AR-07-0453

Southern Nuclear Operating Company
Vogtle Early Site Permit Application
Response to Requests for Additional Information Letter No. 4

Response to February 23, 2007 RAI Letter No 4

Section 2.3 Meteorology

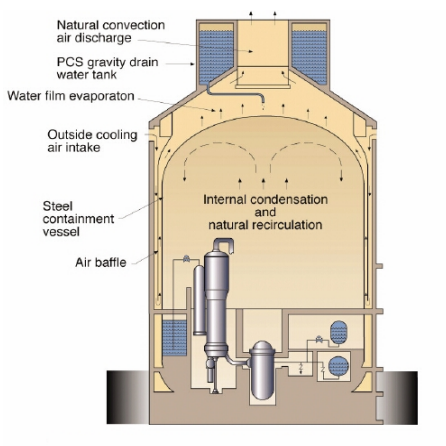
2.3.5-1 Please provide the basis for calculation of the containment building minimum cross-sectional area and equivalent structural height, since this information has been used as input to the XOQDOQ computer code to derive the long-term (routine release) atmospheric dispersion estimates presented in SSAR Section 2.3.5. Please also revise the SSAR as appropriate.

The containment building minimum cross-sectional area contains two parts; the reactor enclosure building plus a PCS water tank on the top. None of the other nearby buildings onsite is included in the calculation.

The height of the entire contiguous building is 234.4 ft (71.4 m) while the bottom (W_B) and the top (W_T) widths of the building are 146.3 ft (44.6 m) and 89 ft (27.1 m), respectively. The height of the PCS is 39.1 ft.

The total calculated cross-sectional area of the structure (A_T) is 31498 ft^2 (2926 m^2). Using this total area, and dividing by the actual building bottom width (146.3 ft), the equivalent structural height is calculated ($H_e = A_T / W_B$) to be 215.2' (65.6 m), assuming that the structure width is uniform in the vertical direction.

These calculated values were input into the XOQDOQ model to predict the required annual average X/Q and D/Q values. SSAR Section 2.3.5 will reflect the details of the above discussion in the next revision to the ESP Application.

Figure C-1. Cooling Tower Effects From an East Wind

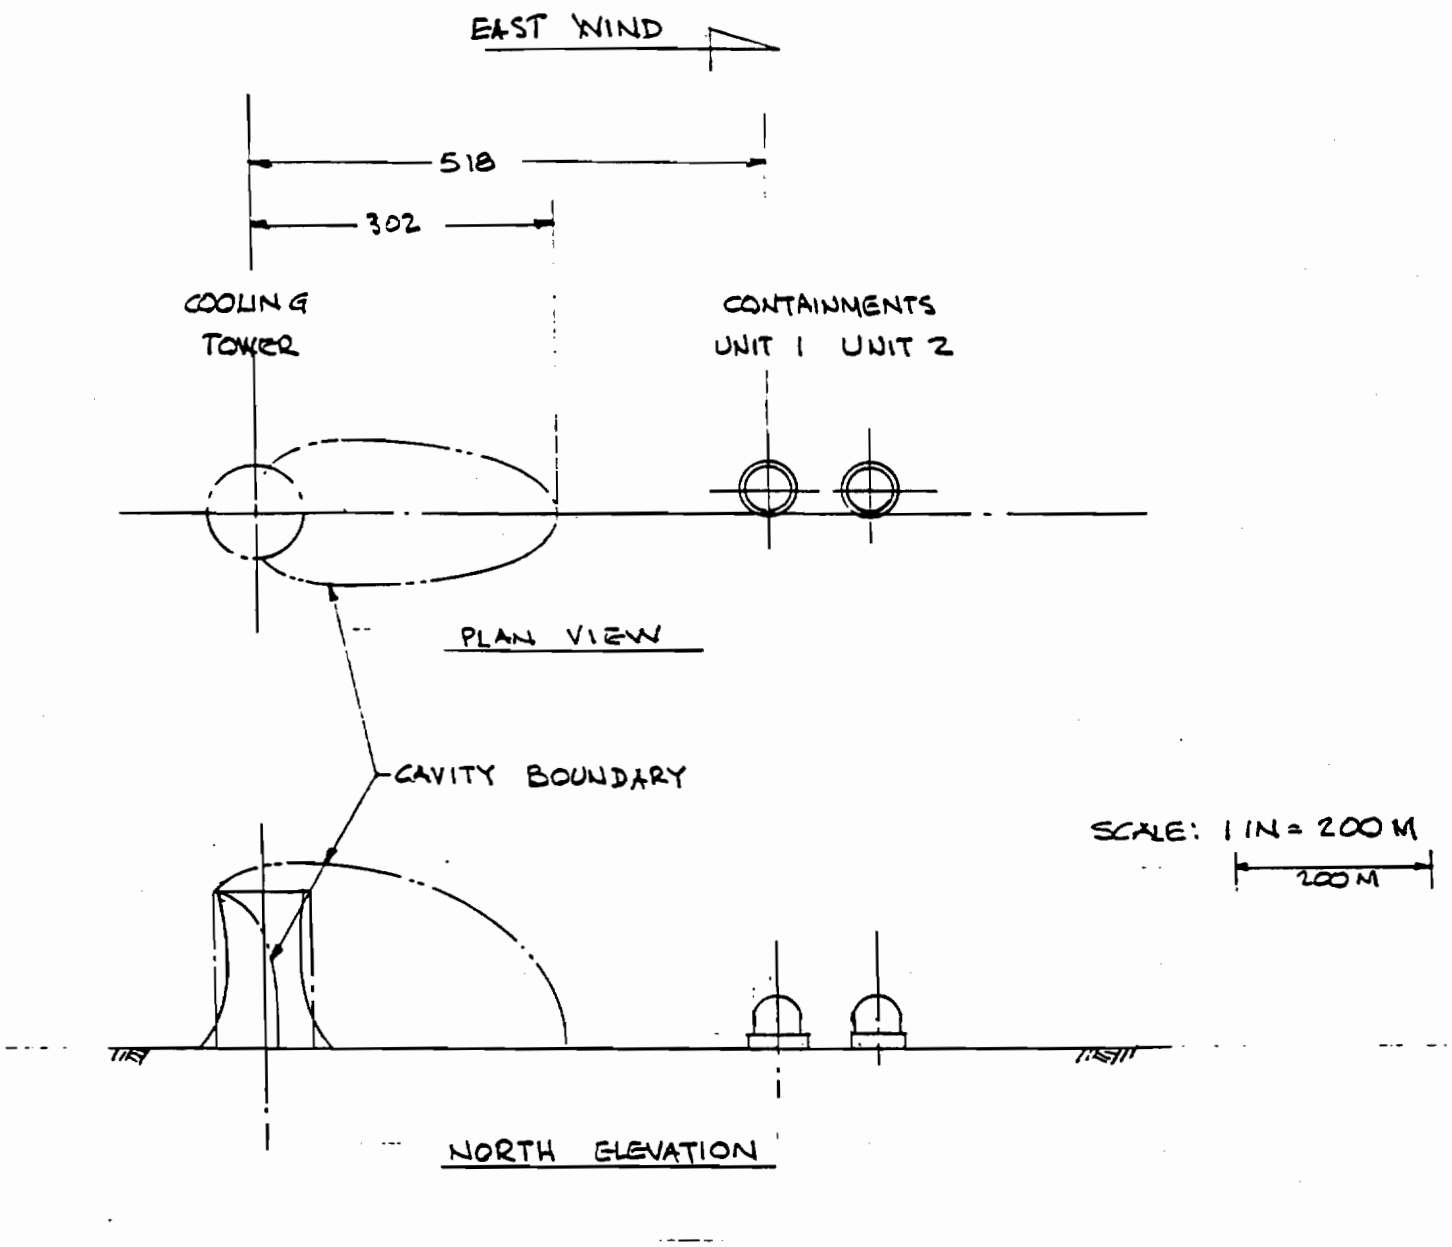
- The natural draft cooling towers appear to be less than 2000 ft from the Unit 1 containment structure, and these structures could significantly influence low-level airflow in the vicinity of the main plant release points for a number of wind directions. Furthermore, plant releases, when the wind is blowing toward the cooling towers, could be entrained into the wake of these structures. For these situations, releases which may have been considered as partially elevated could behave more like ground level releases. Provide additional information on the influence of the natural draft cooling towers on routine releases of radioactive material to the atmosphere.

- Natural draft cooling towers are located generally east of the plant. Therefore, in an east wind, the center of the south cooling tower lies 518m upwind of the center of the Unit 1 containment. The airflow disturbance created by the tower is a cavity attached to the lee surface of the tower, enclosed in an enveloping wake. The tower has the following dimensions: base diameter = 136.5m, throat diameter = 76.2m, top diameter = 84.1m, height = 164m above plant grade which is 219.5 ft MSL. For this analysis, the tower will be considered as a vertical cylinder with diameter d = 97.5m and height H_c = 164.0m, yielding $d/H_c = 0.59$. The length of a cavity created by a vertical cylinder on a ground plane is reported by Hosker in NOAA Oak Ridge ATDL Contr. No. 79/10 as 2.7d when $d/H_c = 1.0$ and 3.1d when $d/H_c = .67$. Using the latter figure, the length of the cooling tower cavity is 3.1 x 97.5 = 302m, which corresponds to a normalized distance $x/H_c = 1.8$. Flow conditions at the end of the cavity exhibit low wind speed and high directional variability. However, these conditions ameliorate with distance downwind. At Unit 1, whose normalized distance from the tower is $x/H_c = 518/164 = 3.2$, the mean velocity deficit is about 17%, according to Hosker Figure 7.26b. No data are available on the turbulence intensity excess nor the streamlined inclination in the vicinity of the Unit 1 release, but these should be small in comparison with flow irregularities created by the plant itself. The net effect of the concentration

increase due to reduced mean velocity and concentration decrease due to increased turbulence should be small. Figure C-1 shows the area affected by the cavity boundary.
